CITY OF KIRKLAND
Planning and Building Department
123 5th Avenue, Kirkland, WA 98033
425.587.3600 ~ www.kirklandwa.gov

MEMORANDUM

To: Design Review Board
From: Scott Guter, AICP, Senior Planner
Date: February 21, 2020
File No.: DRV20-00033
Subject: **203 1ST AVE S MULTIFAMILY PROJECT
CONCEPTUAL DESIGN CONFERENCE**

ARCHITECTURAL MASSING: Scheme Three Preferred WEST VIEW

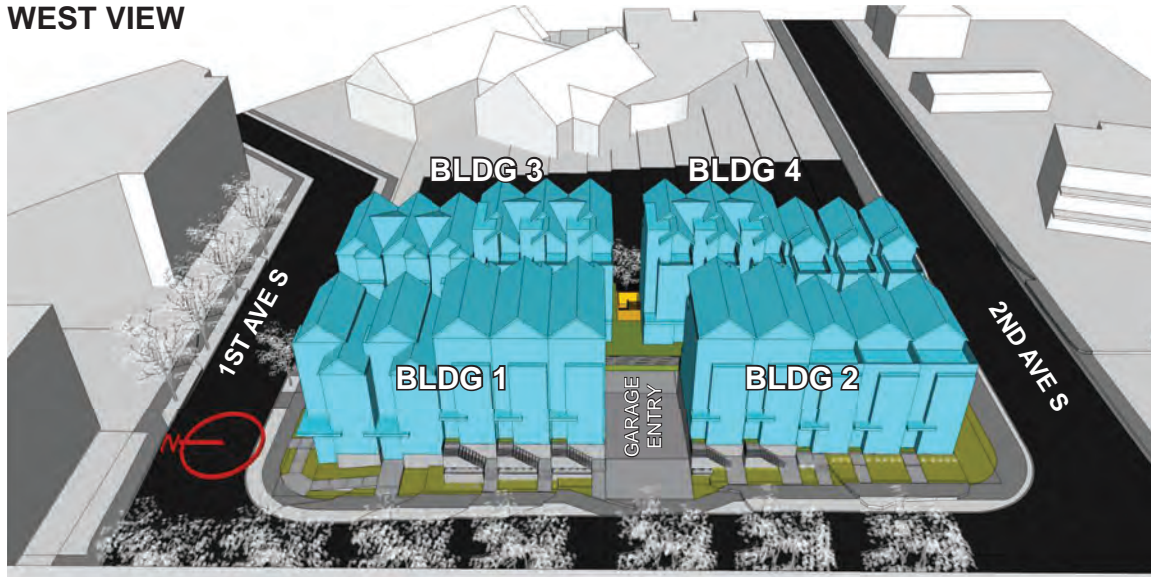
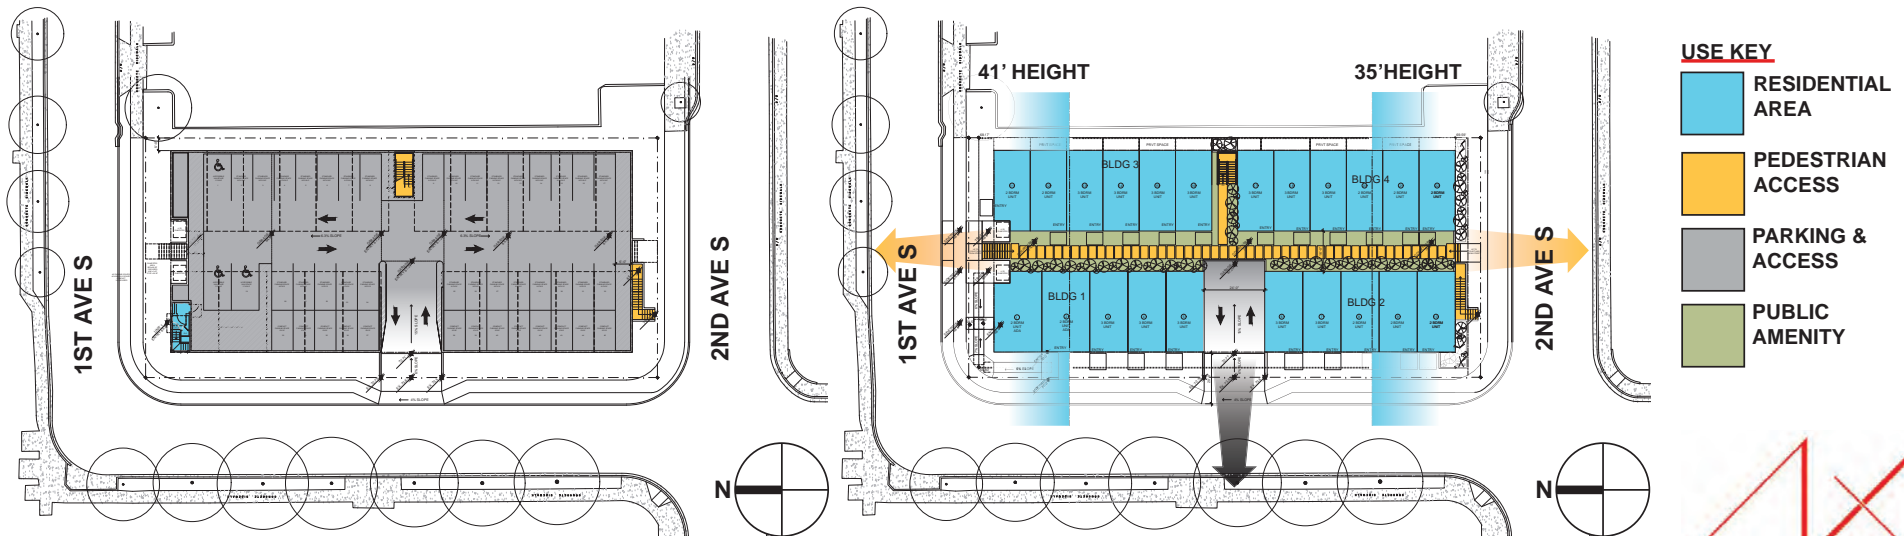
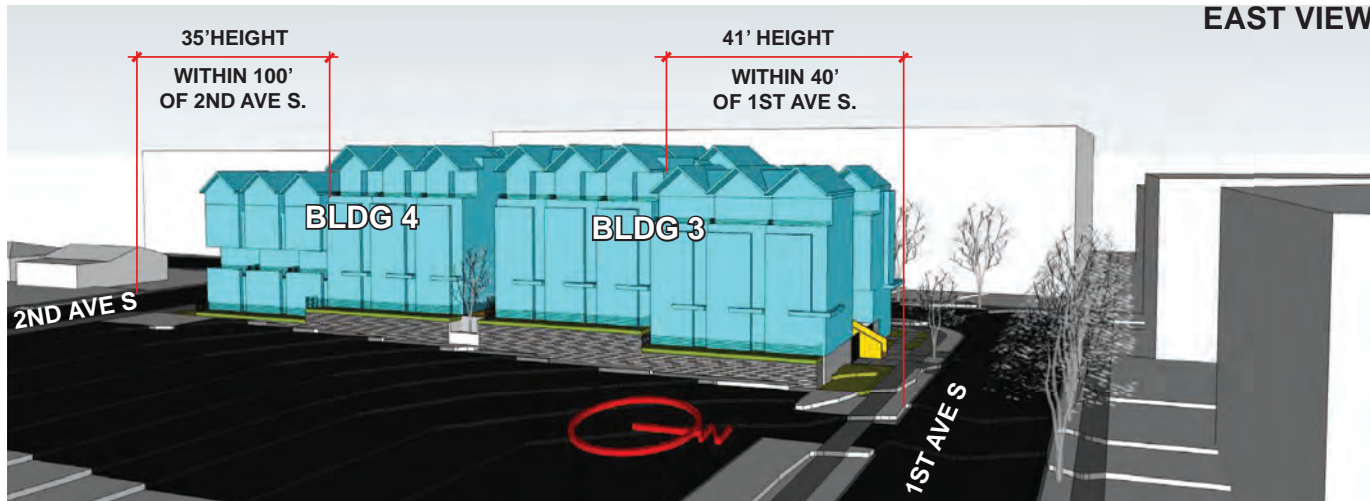
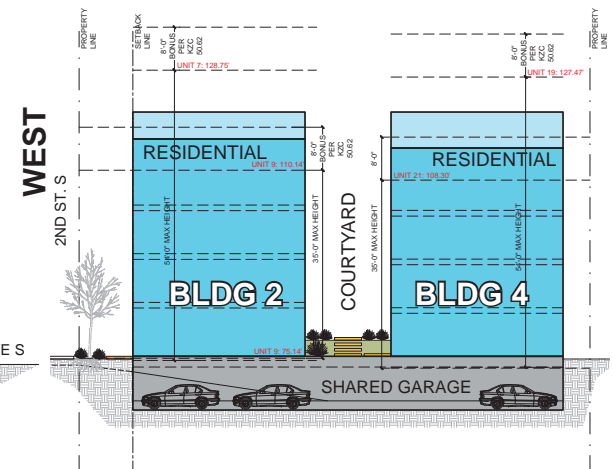
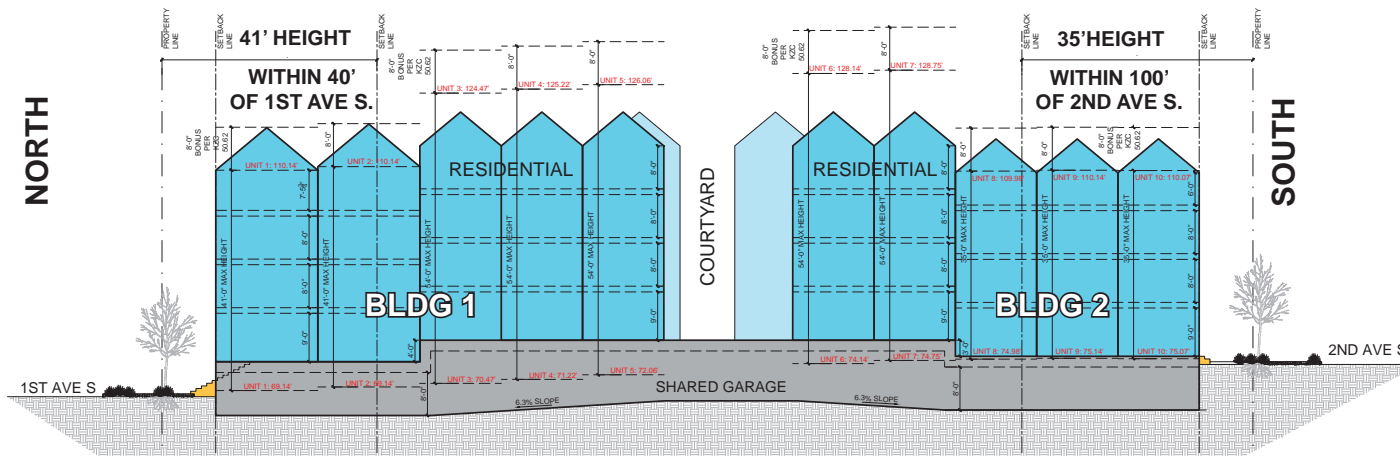
1. What are the key vantages of the project?
2. Identify appropriate mitigation techniques for building massing of the proposed buildings. Possible techniques include vertical and horizontal modulation, corner treatment, and roof forms. The applicant has provided several massing schemes including a preferred option (Scheme 3) for the DRB's review and comment (see Attachment 2).
